# CITY OF ALBUQUERQUE

**Re: Apache Elementary – Kindergarden Addition, 12800 Copper Ave,  
Approval of Permanent Certificate of Occupancy (C.O.),  
Engineer's Stamp dated 12-01-08 (K-22/D003)  
Certification dated: 4-22-09**

**Re: Apache Elementary Kindergarten Addition Grading and Drainage Plan  
Engineer's Stamp dated 1-16-09 (K22/D003)**

**Re: Apache Elementary Kindergarten Addition Grading and Drainage Plan  
Engineer's Stamp dated 12-1-08 (K22/D003)**

SECTION C-C

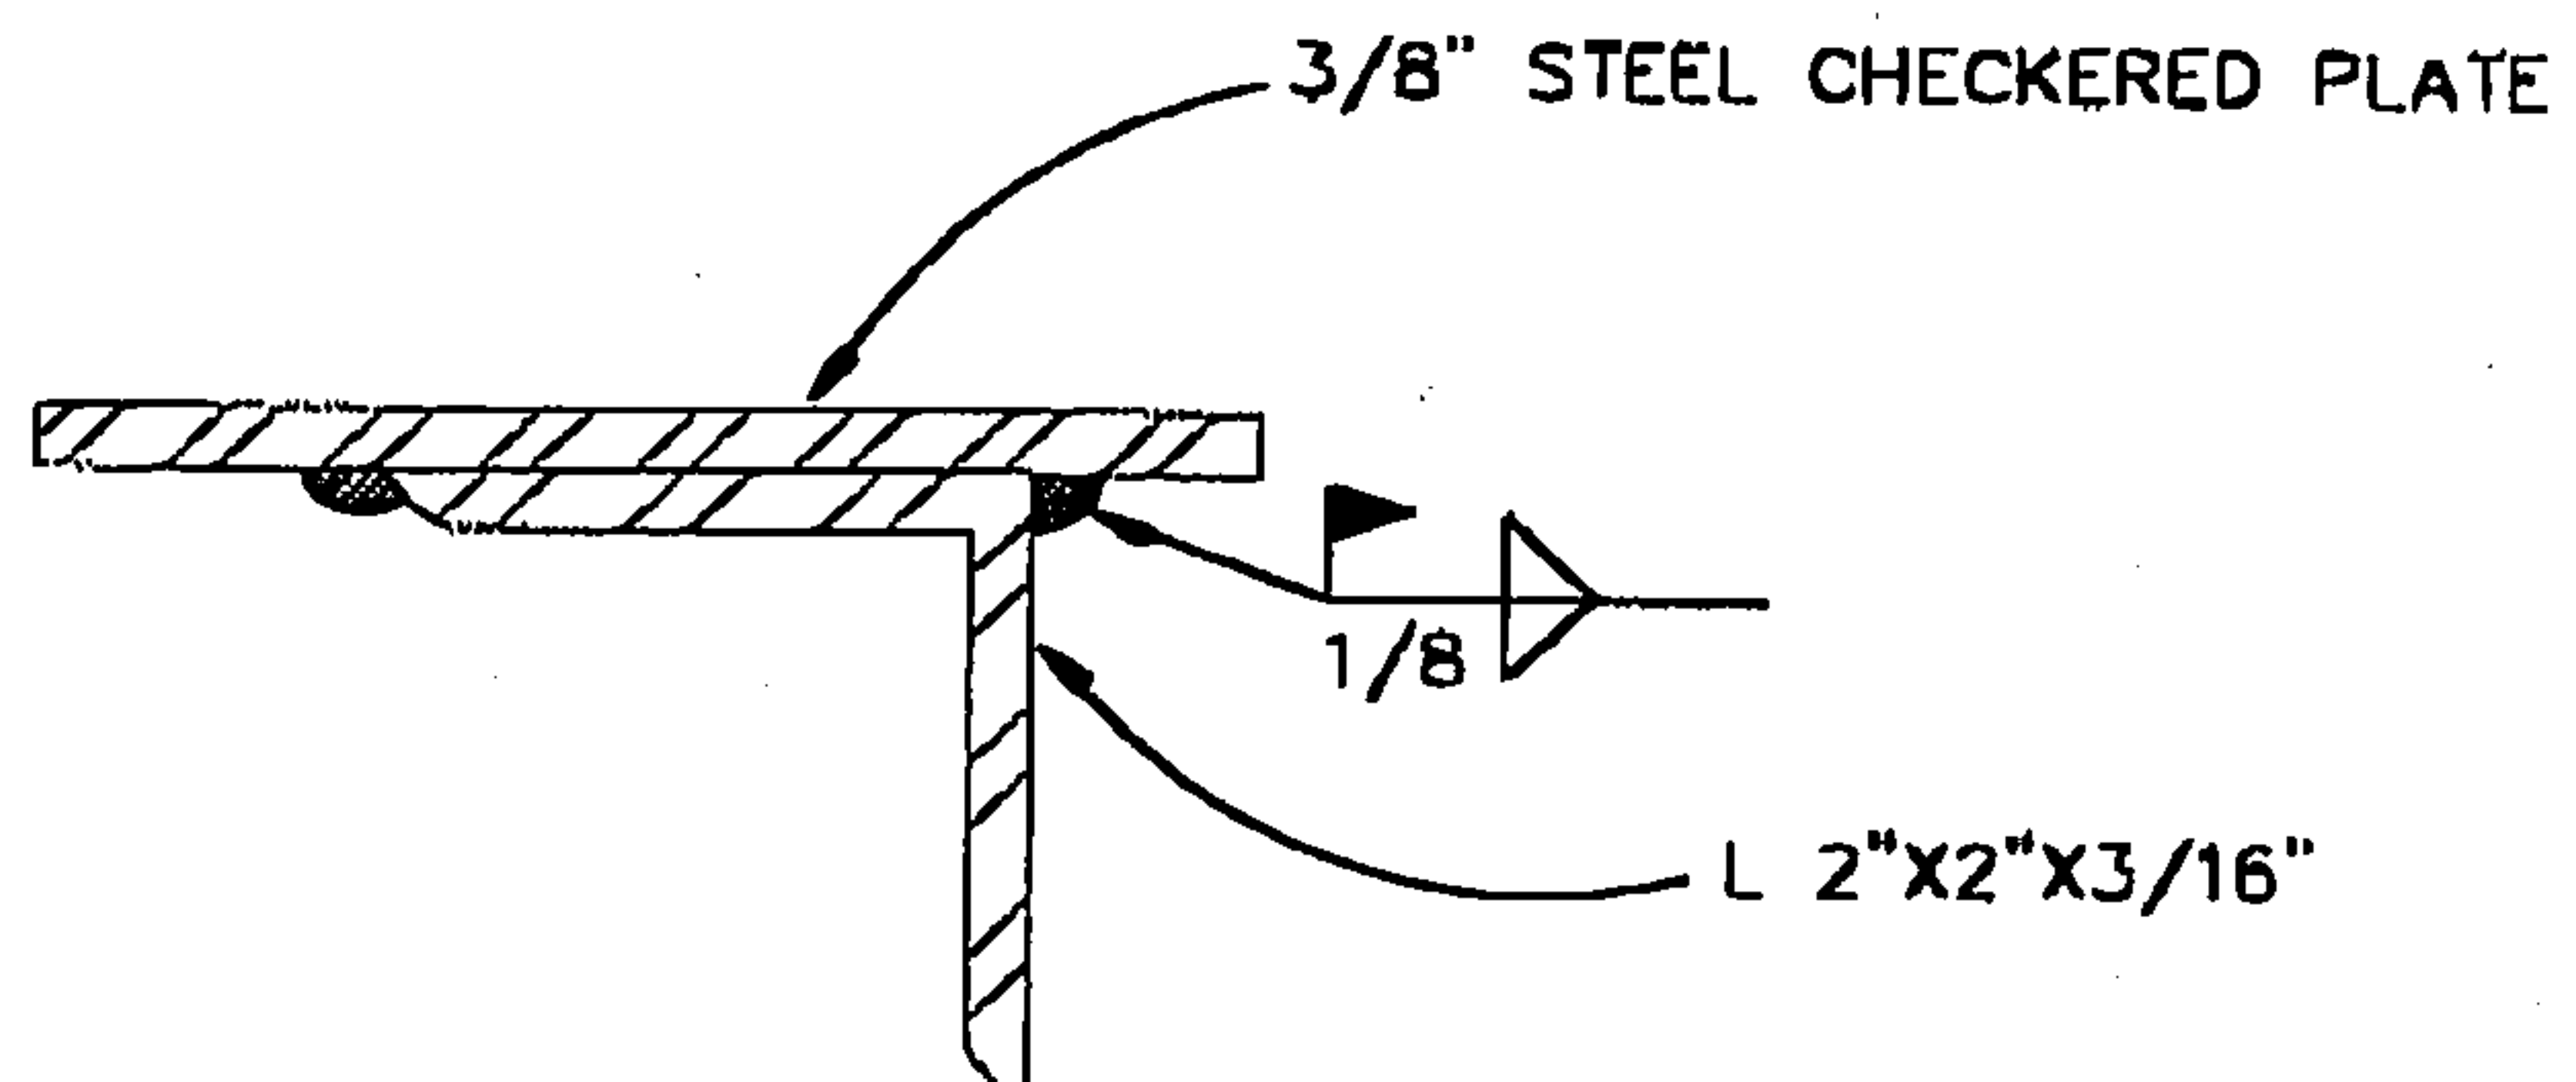
The run-down extends from the back of the sidewalk culvert approximately 7 feet to the fence at the boundary of the school. There is an existing fence opening inside of the run-down which the children use as access to the school. Mr. Lukins' concern is as follows:

1. A safety concern may exist with the 7 feet of open rundown;

- 1 USE TWO STEEL PLATES TO COVER RUNDOWN. EACH PLATE SHALL COVER HALF OF THE RUNDOWN.
- 2 THE NEW STEEL PLATE AND FRAME MEMBERS SHALL BE PAINTED PER COA STD. DWG. #2236.
- 3 THE NEW STEEL PLATE SHALL BE ANCHORED TO CONCRETE AS SHOWN IN SECTION B-B OF COA STD. DWG. #2236.
- 4 THIS DRAWING ADDRESSES THE RUNDOWN COVER ONLY. THE CONTRACTOR SHALL COORDINATE WITH THE COA STREET MAINTENANCE DIVISION TO DETERMINE THE EXTENT OF THE WORK ON THIS SIDEWALK CULVERT NECESSARY TO BE APPROVED FOR OCCUPANCY.
